Further submission to Independent Planning Commission: St Leonards South Planning Proposal

Overview

Figure 1: Adapted from Lane Cove LEP Heritage map

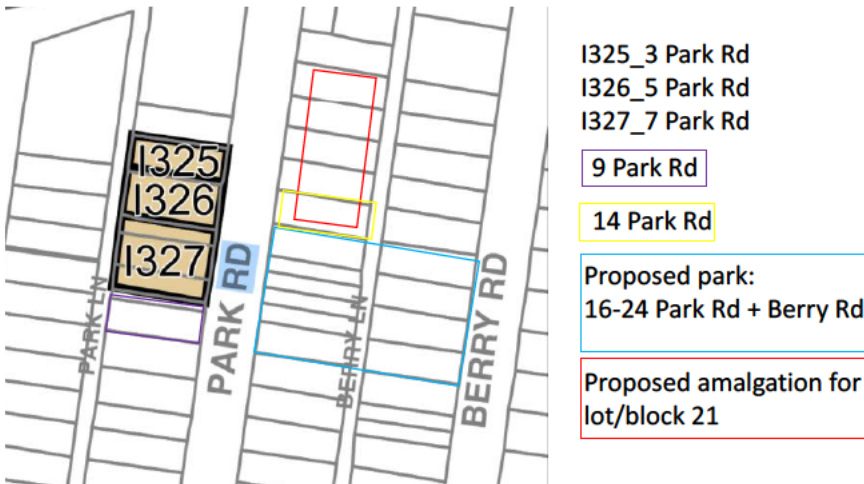
Council persists in misrepresenting the location of the heritage properties relative to the proposed park:

"So two of the heritage items are directly opposite to the park. One is not" (transcript P45:16)

Is there some confusion about the location of the heritage-listed properties?

- Only one of the heritage-listed properties, 7 Park Road, is directly opposite the proposed park (refer Figure 1).
- 9 Park Road is also opposite the park, but it is *not* heritage-listed.
- 5 Park Road has a metre or so of land along its southern boundary that will oppose the northern boundary of the proposed park. Overwhelmingly, the heritage-listed site at 5 Park Road (including the entirety of the dwelling) is opposite 14 Park Road, which forms part of the land parcel designated for amalgamation as block 21.
- No part of 3 Park Road is opposite the park.

Figure 3: Developer-proposed increases (in red) to façade and massing on Park Road frontage (extracted from design report accompanying DA 14/2019).

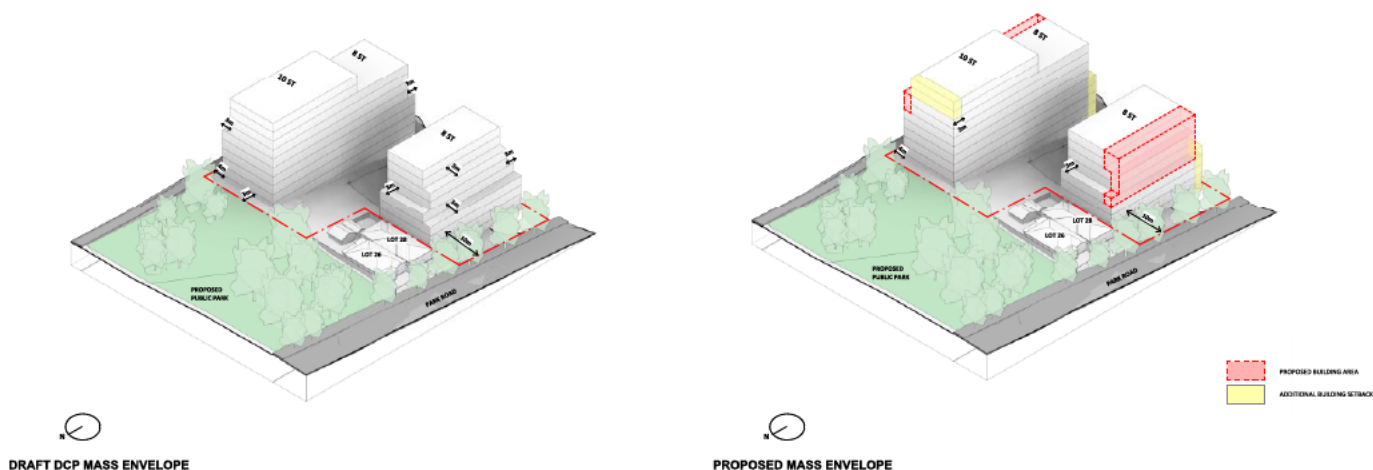
- the DA (14/2019) for the Park Road/Berry Road site (Greaton) alters the proposed setbacks and dimensions of the façade fronting Park Road, resulting in a significantly increased building mass on (and close to) the Park Road frontage, with particular impacts on the single-storey dwellings on the other side of Park Road (see Figure 3).

Figure 4: Developer-contested height limit, subject area outlined in black (adapted from proposal LEP and DCP plans)

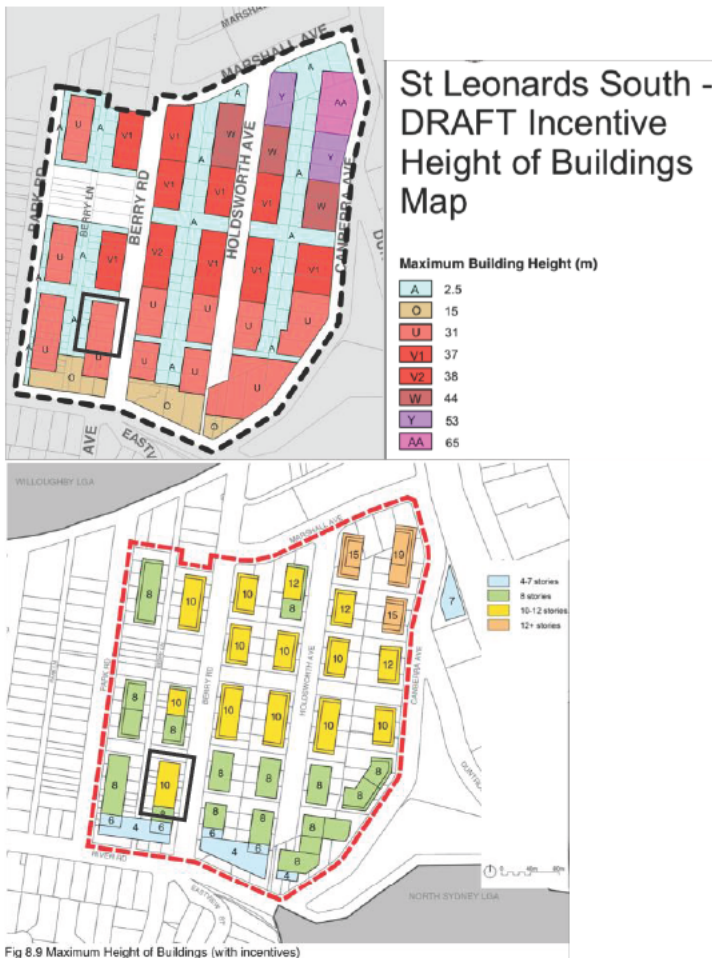
- Further, a 31m height limit provided for in the DCP is challenged by one of the developers (Country Gardens St Leonards), which argues that it should be 37m – claiming it is an anomaly that does not permit the 10 storeys of development agreed with Council (Public Hearing Transcript P32:5). We understand Council agrees it has made a mistake – which seems a fairly significant mistake in the circumstances. This affects the site bounded by Park

Road, Berry Road and River Road, and so is relevant to overshadowing and transition to low density in the south western section of the proposal area. This discrepancy is evident from comparison of the LEP building height diagram and the DCP building heights (refer Figure 4). The impact of this revised 37 metre building height (if correct) should be assessed in shadow modelling, particularly affecting the south side of River Road.
